ENABLING DC COUPLED CHANNELS (COMMENT #58)

Adee Ran, Intel

March 2020

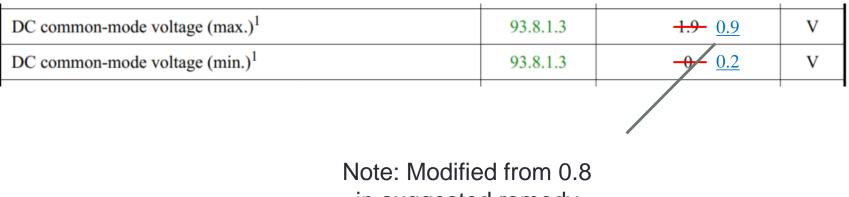
As was discussed in the January 2020 meeting there is interest in enabling DC-coupled channels in some applications (mainly backplane and C2C) when the two link partners support this operation. Avoiding AC coupling capacitors in the channels can help board design, improve signal integrity, and reduce costs, and it is becoming a common requirement.

Current channel specs refer back to 93.9.4 where it is stated that AC coupling capacitors may not exist between TP0 and TP5, but in that case some specifications may need modifications for interoperability (without stating the modifications explicitly). This leaves the burden of defining new Rx and Tx specifications to implementers and integrators - with no standard to assist them.

Indeed, the current transmitter specifications in 120F.3.1 and in 163.9.1 allow high common mode voltage up to 1.9 V, which is detrimental for DC coupling with modern CMOS devices. This high value is also not useful for Tx design with modern applications.

DC coupling can be supported by limiting the Tx common mode voltage to a more reasonable and useful range. If this is done, the existing specs may be useable without change for DC coupled channels (although receivers may still need special support for this).

In the transmitter characteristics tables of Clause 163 and Annex 120F, Change the Tx common mode voltage to be between 0.2 and 0.8 volts.

Change common mode voltage specifications in both Table 163–5 and Table 120F–1 as shown:
